City of Richmond Hill
Building Division

These drawings have been reviewed under
Compliance Option: **PERFORMANCE**
of the OBC 2012, SB-12.

38-11 Belvedere

Centrefield, Ph. 2

LEFT SIDE ELEVATION 'C'

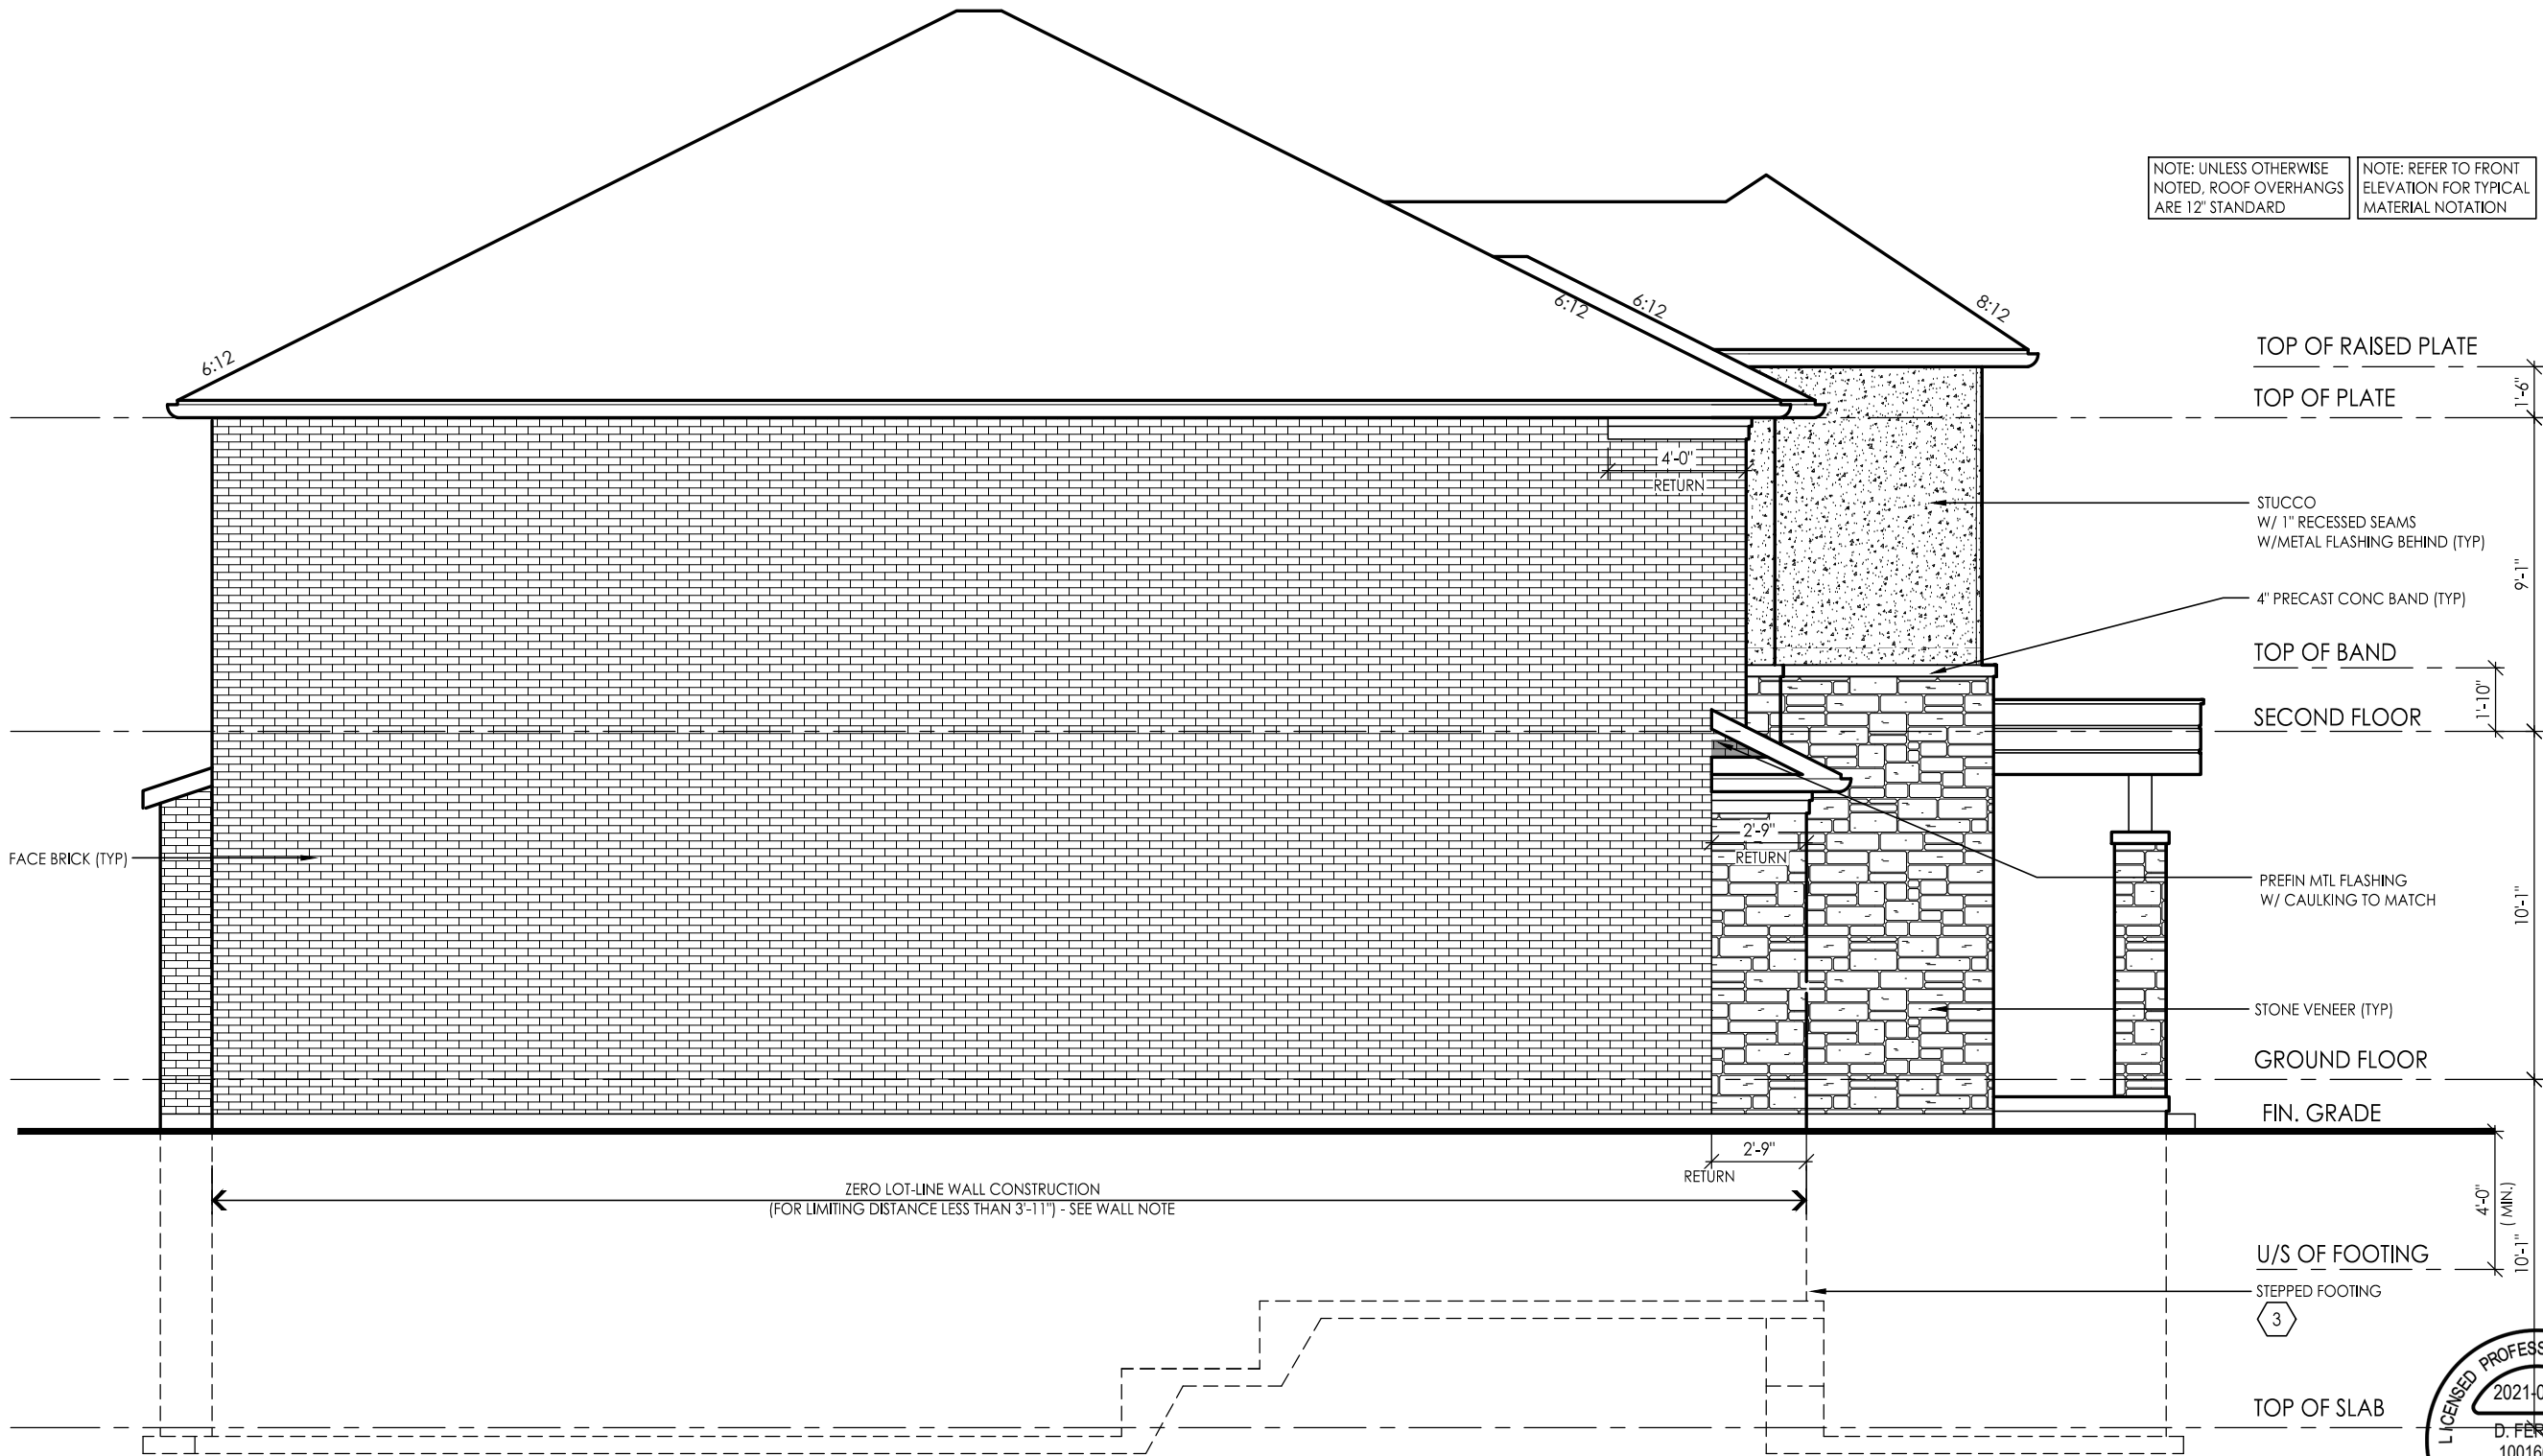
No unprotected openings permitted within 1.2 meters of the lot line as per article 9.10.14 of the Ontario Building Code.
